Access Compliance Report

Public Rights-of-Way

Intersection ID: 30575	Main Street: CIRCLEGREEN_DR	Cross Street: GROVE_CREEK_LN	Location: SW
ADA ID: 8736A4F4061D	Ramp Type: Perp	Initial Pass/Fail: Fail	Overall Compliance: No
Severity Score: 13.75			
Codes/Mitigation Info/Possible Solution		Field Measurements/Component Compliance

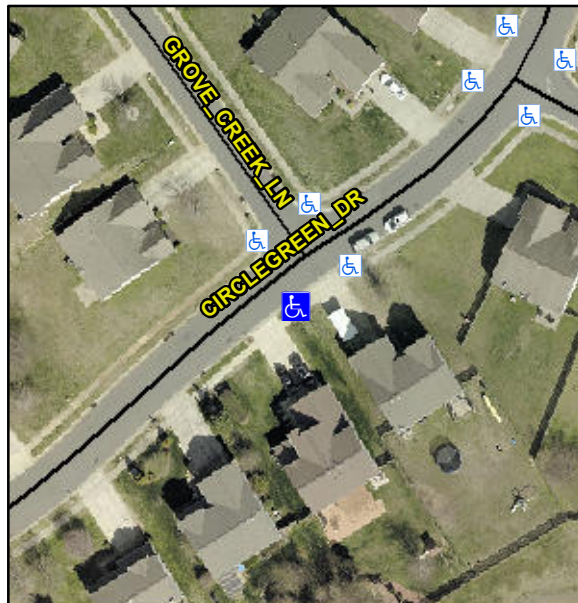
R304.2.2, R304.5.3

Compliance	Description	Data	Compliance	Description	Data
N/A	Ramp Length (in)	45.5	No	Ramp Slope (%)	8.9
Yes	Ramp Width (in)	48.0	No	Ramp XSlope (%)	3.5
N/A	Flare Type LT	N/A	N/A	Flare Type RT	N/A
N/A	Flare Slope LT (%)	N/A	N/A	Flare Slope RT (%)	N/A
N/A	Flare Traversable LT?	N/A	N/A	Flare Traversable RT?	N/A
N/A	Landing Length (in)	N/A	N/A	DWS Provided?	N/A
N/A	Landing Width (in)	N/A	N/A	DWS Contrast?	N/A
N/A	Landing Slope (%)	N/A	N/A	DWS Length (in)	N/A
N/A	Landing X Slope (%)	N/A	N/A	DWS Full Width?	N/A
N/A	Landing Curb? (Y/N)	N/A	N/A	DWS Offset (in)	N/A
N/A	Shared Landing?	N/A			
N/A	Gutter Ponding?	N/A	N/A	Gutter Slope (%)	N/A
N/A	Gutter Lip Ht (in)	N/A	N/A	Gutter X Slope (%)	N/A
N/A	Painted X Walk1?	No	N/A	Painted X Walk2?	N/A
	X Walk 1 Direction	To NW		X Walk 2 Direction	N/A
N/A	X Walk 1 Width (in)	N/A	N/A	X Walk 2 Width (in)	N/A
	X Walk 1 Slope (%)	2.4		X Walk 2 Slope (%)	N/A
	X Walk 1 X Slope (%)	1.6		X Walk 2 X Slope (%)	N/A

Remove & Replace Entire Ramp.
